DELEGATED APPLICATION REPORT

App Ref: PL/26/0754 Full planning permission

Address: 29 CASTLE STREET, READING

Proposal: Relocation of existing plant to upper roof level, creation of roof terrace for office use, installation of solar photovoltaic panels, erection of parapets and plant screening and associated works (amended)

Figure 10 – View on 31 Castle Street.

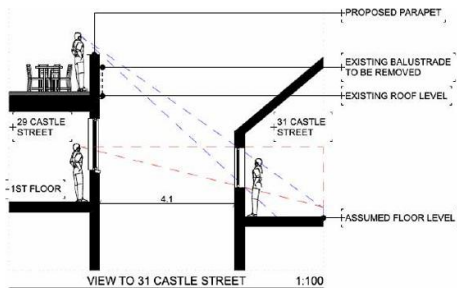
The submitted overlooking assessment demonstrates that opportunities for direct overlooking are limited and that the proposed balustrade arrangement would further restrict views towards neighbouring windows.

It is not considered that the new views created from the proposed terrace would be significantly different to the existing views due to the context of the existing window arrangements.

Possible view from the terrace creates less impact than existing views from 1st floor

The design of the terrace has incorporated measures to further reduce the potential for overlooking. Solid parapet walls are provided along the boundaries with neighbouring properties, helping to minimise overlooking in these directions. In contrast, a more open metal balustrade with vertical uprights is proposed along the rear edge of the terrace, directing views southwards.

Taking into account the existing building arrangement, the separation distances, and the modest scale of the terrace, the proposal is not considered to give rise to any material adverse impacts on the residential amenity of neighbouring occupiers, subject to conditions.
